Domain	GEOLOGY
MMDD's item no. for the question which includes the observation identified by the RMGC internal code	4
MMDD's identification no. for the question which includes the observation identified by the RMGC internal code	Alba Iulia, 31.07.2006
RMGC internal unique code	MMGA_0011
Proposal	Why isn't anything stipulated in the project with respect to other metals present in the ore deposit that will be mined, i.e. the three metal groups: heavy metals (uranium, copper, and lead), precious metals (gold, silver and platinum) and rare metals (wolfram, molybdenum, iridium, germanium), why only gold and silver are mentioned?
Solution	<p>Gold and silver are the only metals that can be profitably mined in the area. RMGC commissioned a series of petrographic studies on samples and analytical test work that tested the concentration levels of 47 elements in Roşia Montană deposit. Except for gold and silver, the elements' concentration falls, in most cases, below the average levels found in the Earth's crust: U (1.43 ppm compared to 3.7 ppm), Th (6.07 ppm compared to 18 ppm), Sr (95.4 ppm compared to 125 ppm), Mo (1.27 ppm compared to 1.5 ppm), In (0.05 ppm compared to 0.1 ppm), Ge (0.21

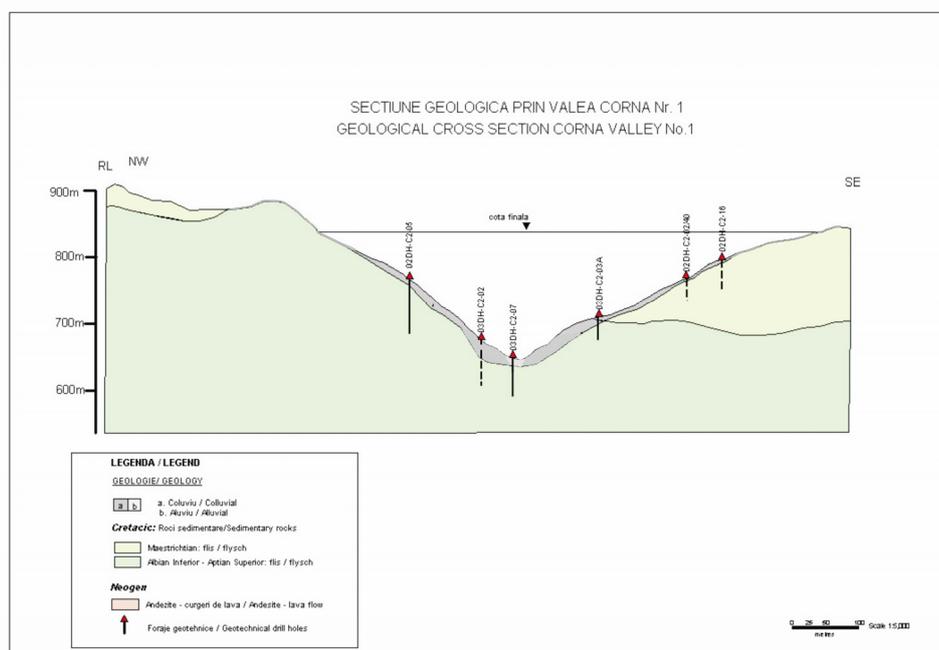
The questioner needs more information on the tectonics of the area surrounding the tailings management facility, namely geological sections that will reveal the faults, given the fact that this is a faulted, highly tectonized area.

Chapter 4.5 of the EIA report presents in detail the geology of the area, including drawings of the regional and local geology. For the tailings pond, cross sections of the tailing pond are presented in the Annexes of the *Technological Processes* section: Figure: 2.19 – Scheme of the tailing pond system and Figure 2.20 – Transversal cross section of the tailings pond dam and of the retention secondary dam. In the *Tailings Facility Management Plan*, Figure 5.2 presents the geological profile along the tailing pond. Drawings 03A; 03B; 07A; 07B and 09 show cross sections of the main and secondary tailing pond. Data from the geotechnical study is described in section 2.3 (page 28) within the same plan. All the plans and cross sections present the faults, geological structure and geotechnical conditions. Geotechnical data were collected from an extensive geotechnical research program conducted over the period 2000 – 2006.

Please see the geological profiles of Corna Valley that are attached to this answer.

In the geological profiles of the tailing pond projected for Corna Valley, there are no known faults that could endanger the safety of the pond.

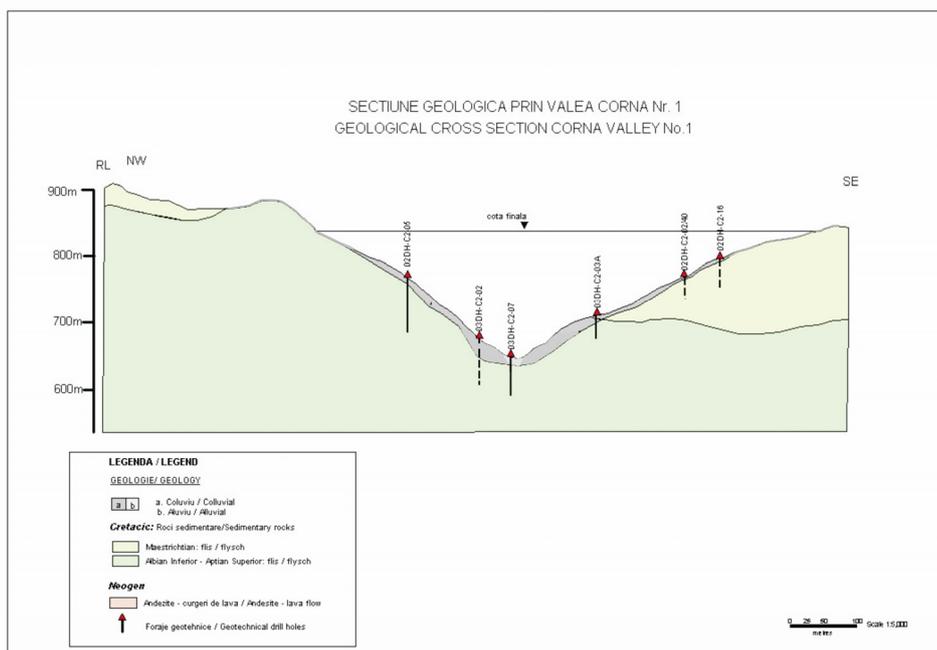
EIA does not present any map with the real geological and tectonic situation of the area

Chapter 4.5 of the Assessment Study of the EIA presents in detail the geology of the area, including drawings of the regional and local geology. For the tailing pond, cross sections of the tailing pond are presented in the Annexes at *Technological Processes*: Figure: 2.19 – Scheme of the tailing pond system and Figure 2.20 – Transversal cross section of the tailing pond dam and of the retention secondary dam. In the *Tailings Facility Management Plan*, Figure 5.2 presents the geological profile along the tailing pond. Drawings 03A; 03B; 07A; 07B and 09 show cross sections of the main and secondary tailing pond. Data from the geotechnical study is described in section 2.3 (page 28) within the same plan. All the plans and cross sections present the faults, geological structure and geotechnical conditions.

Please see the geological profiles of Corna Valley that are attached to this answer. In the geological profiles of the tailing pond projected for Corna Valley, there are no known faults that could endanger the safety of the pond.
